ADDENDUM NO. 2**BID NO. 19-07****MIDDLETON ROAD EXTENSION
CITY OF ABERDEEN, MARYLAND**

To all holders of the specifications, the following corrections are hereby made. All other items shall remain unchanged. This addendum shall become part of the Contract Documents for the above referenced project.

- **Section 1: Answers to Questions Posed by Bidders**
- **Section 2: Updated Bid Schedule**
- **Section 3: Crosswalk and Crosswalk Line Detail**
- **Section 4: Revised Construction Drawings**

WATERMAIN & PROFILE - STA. 10+00 TO STA. 18+26.98
SCALE: 1"=40' HORIZONTAL
1"=4' VERTICAL

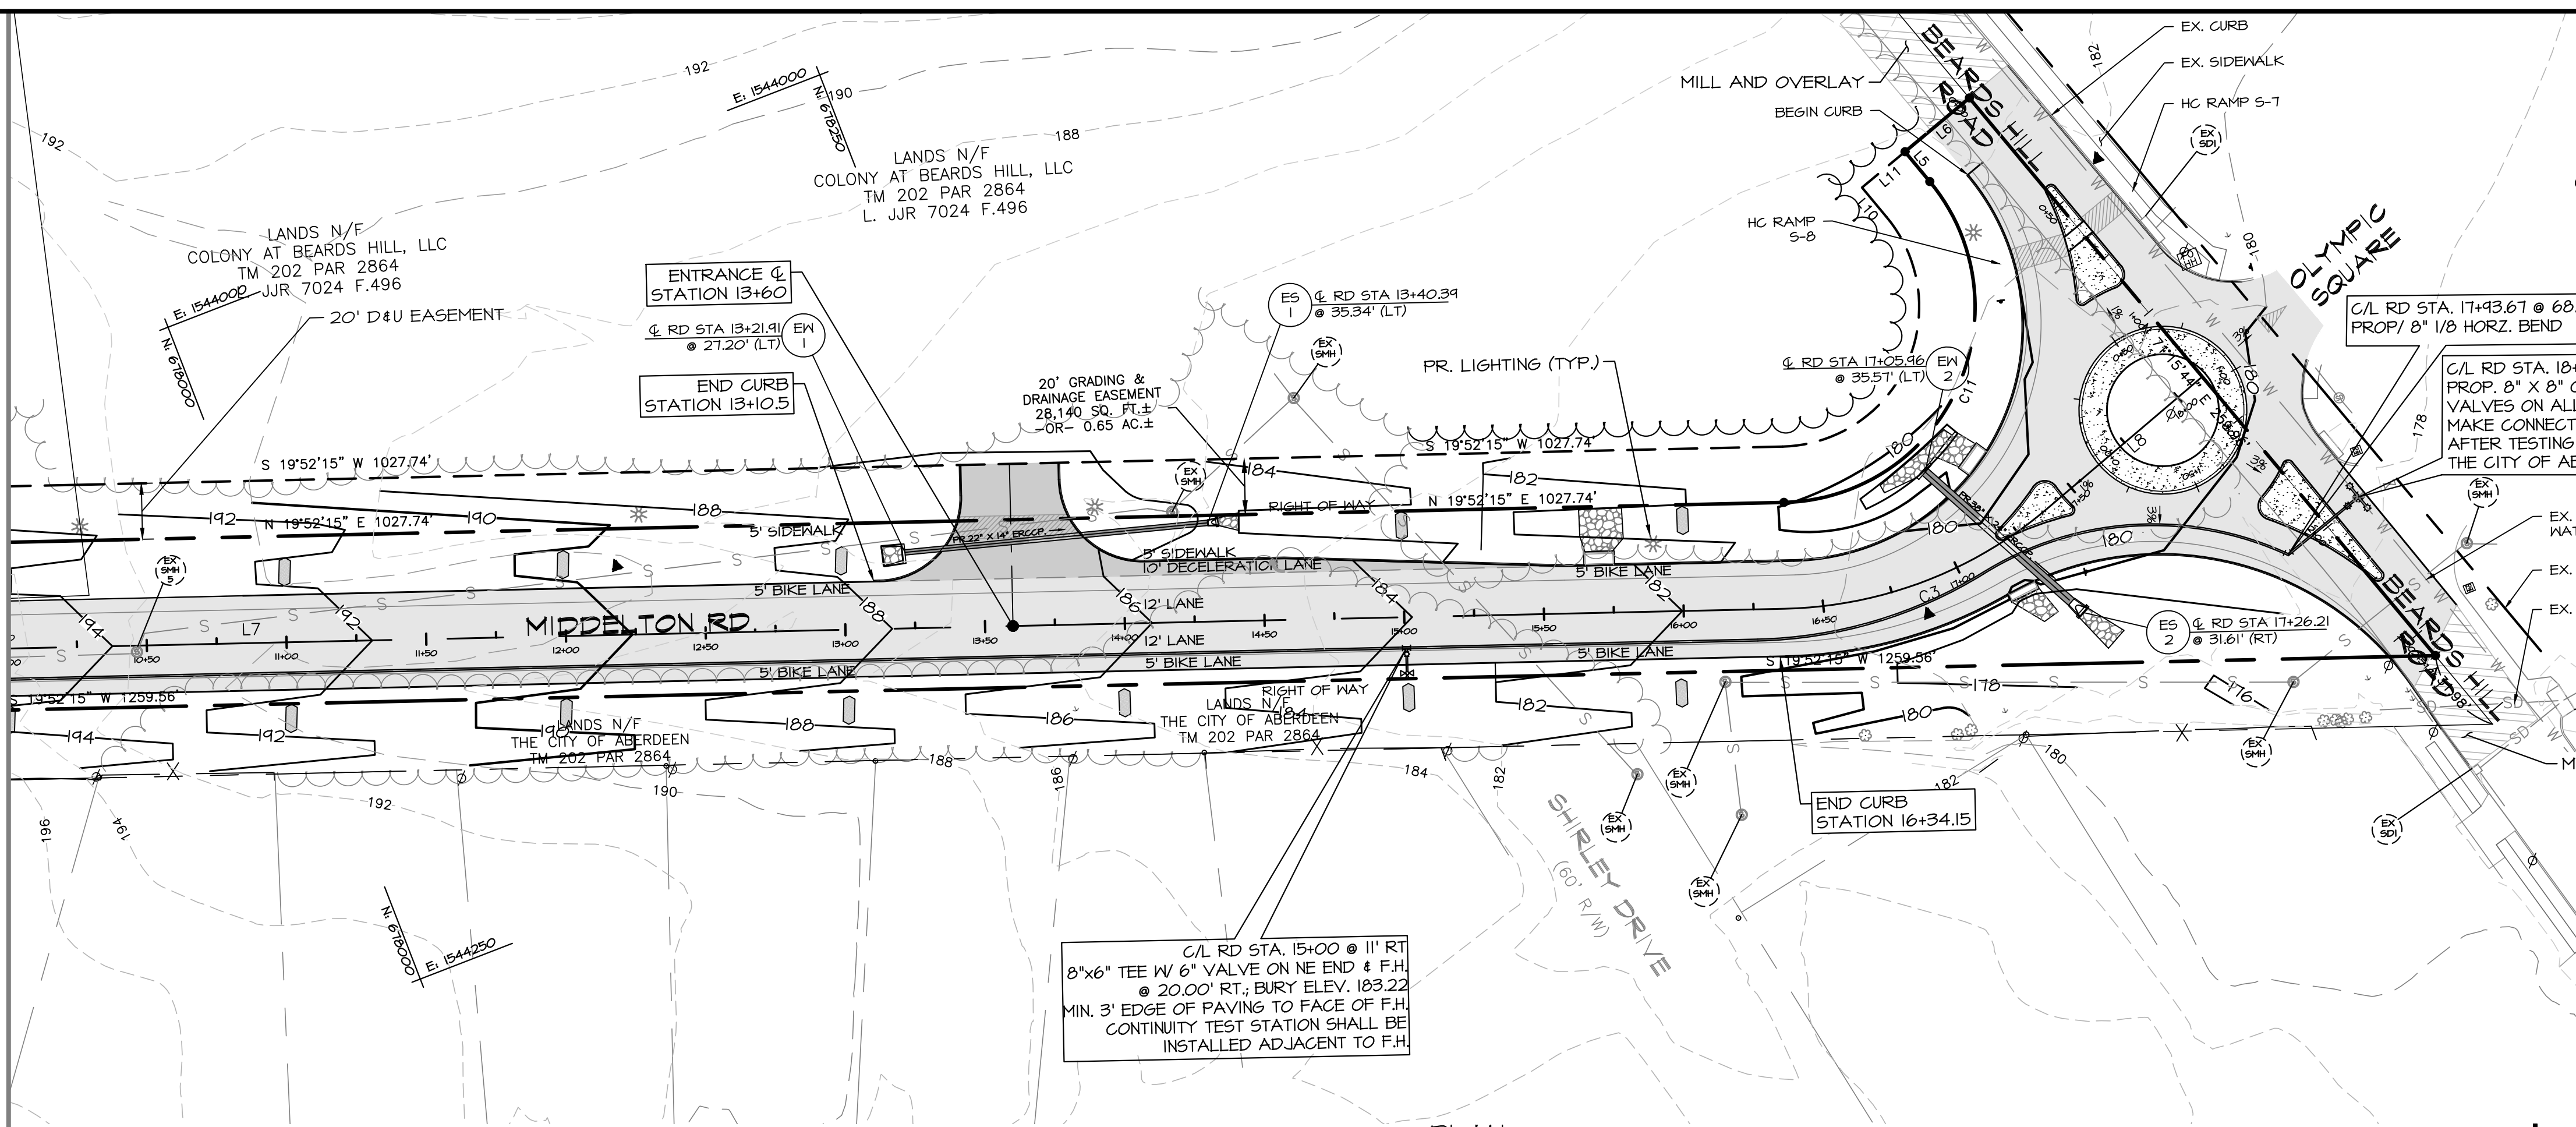
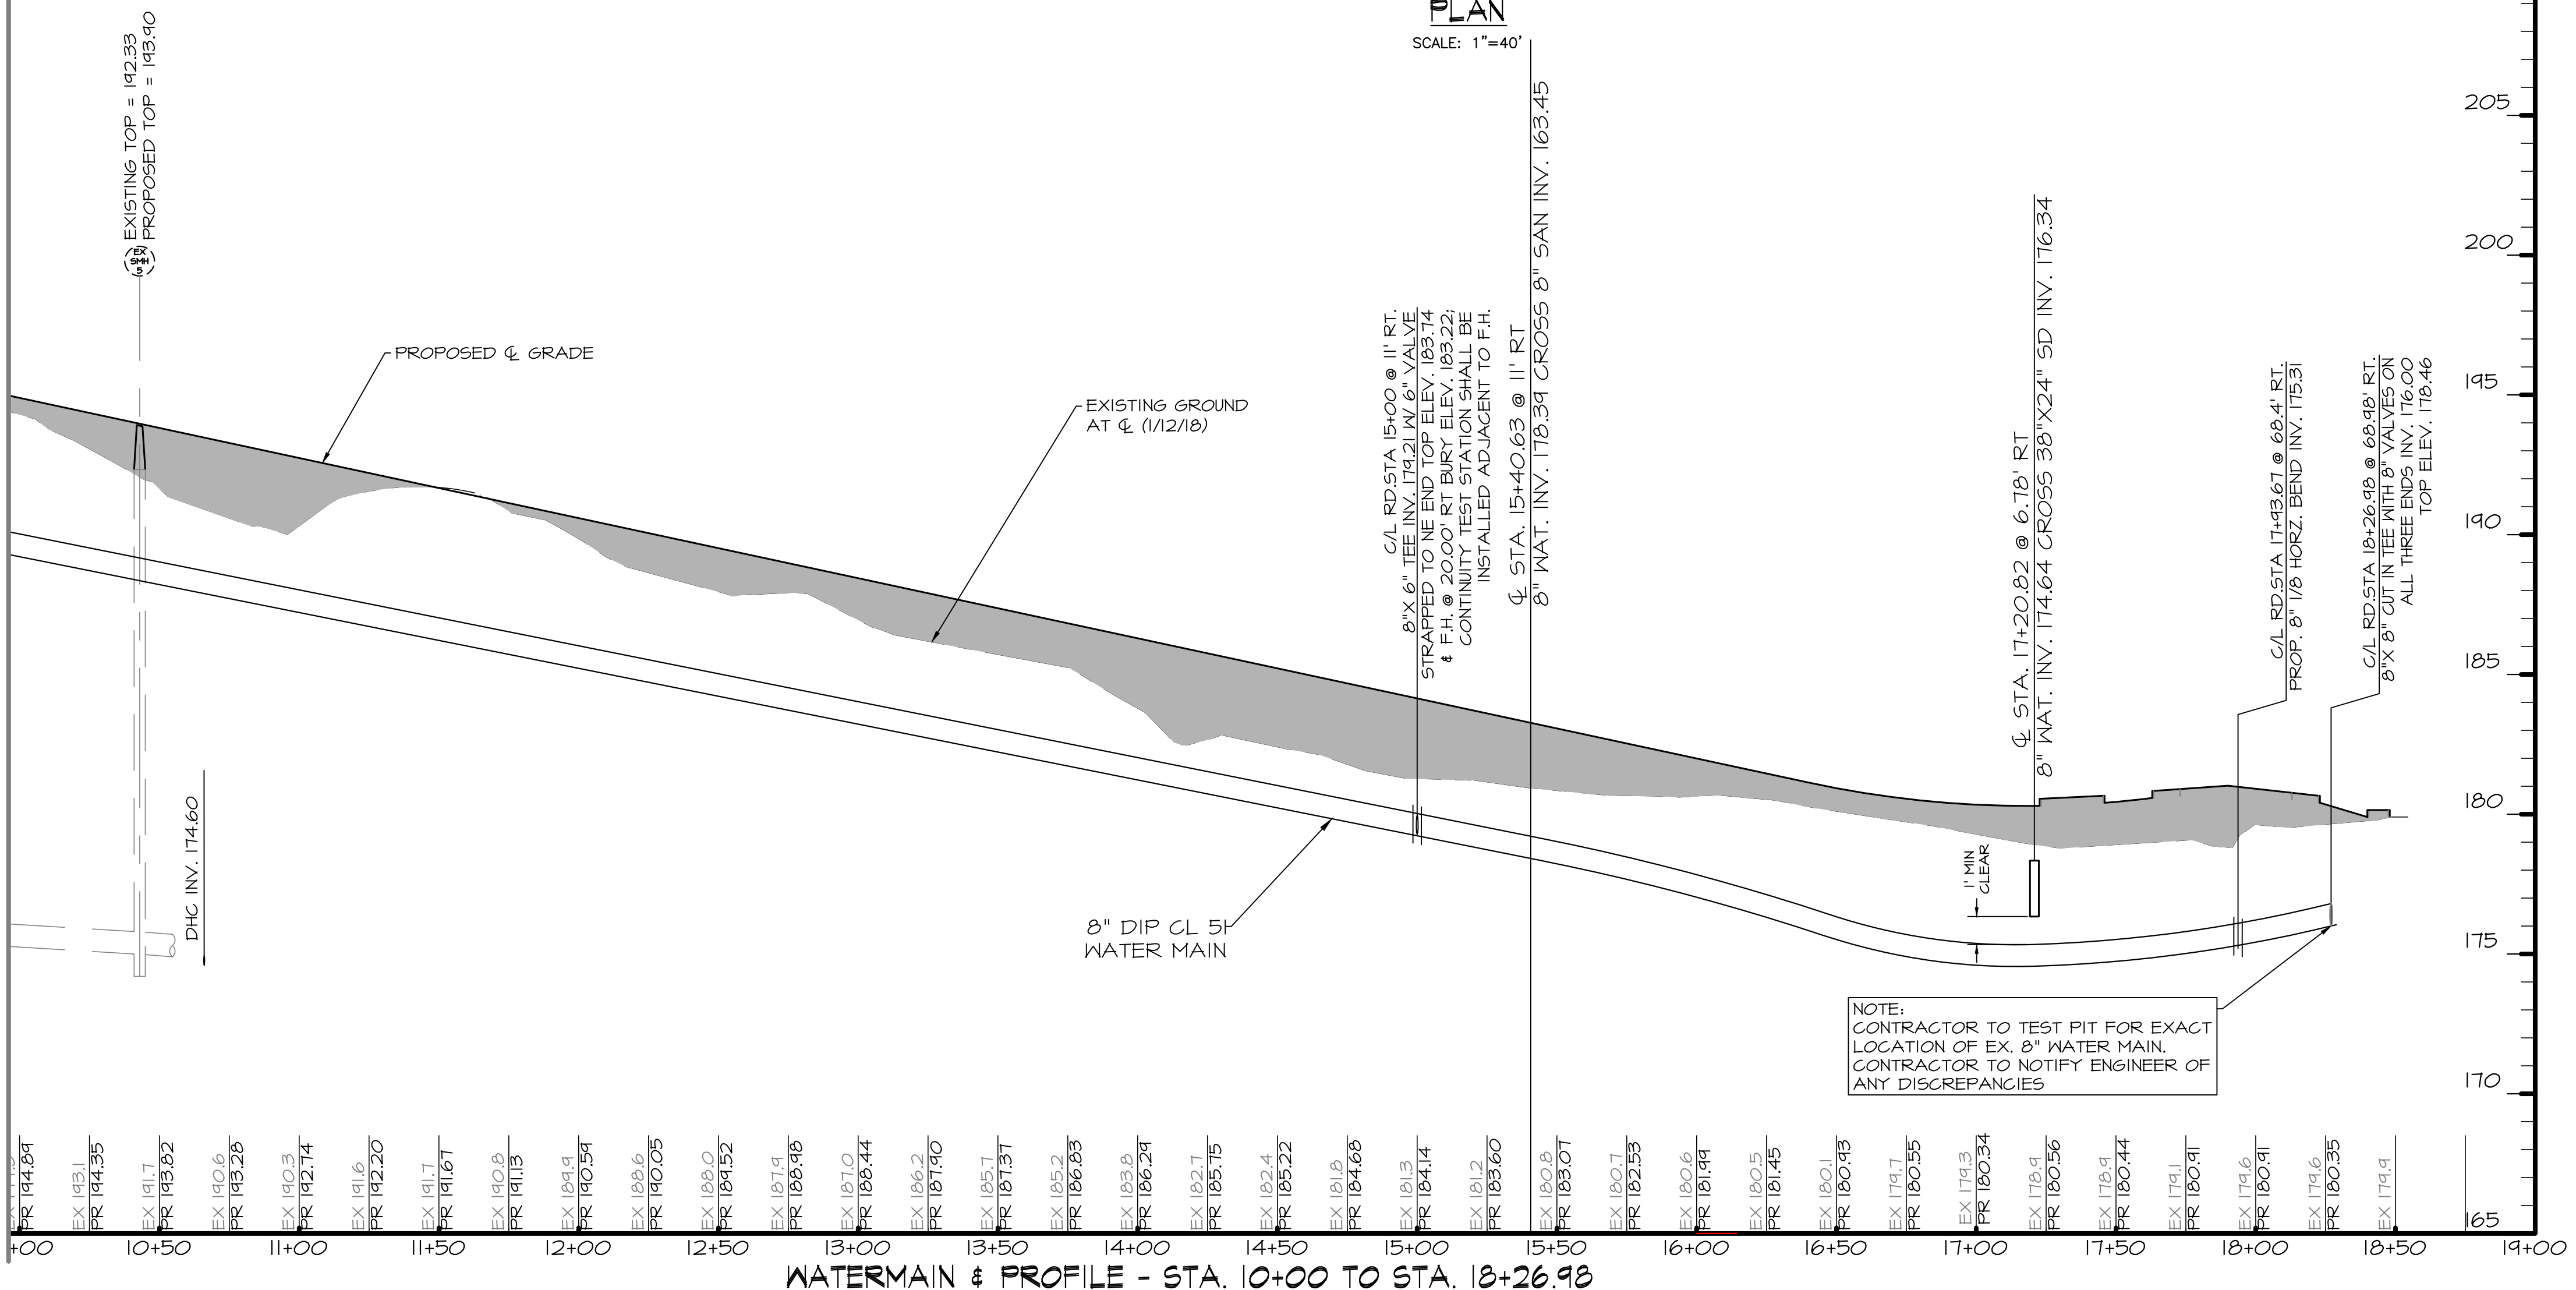
Q29: For the waterline work, who is responsible for exercising the valves for tie-in purposes? Will a tapping sleeve and valve be acceptable for the tie-in at station 18+26? If a cut in tee and valve is the only approved method, will the shutdowns be allowed during the daytime?

Q33: Class 51 is shown on the drawings, is this correct?

A29: The City will work with the Contractor to shut-off the water for the tie-in. A tee and valves will be required. A temporary shutdown will be allowed but must be coordinated with the City.

A33: The waterline will be C900 pipe with appropriate fittings.
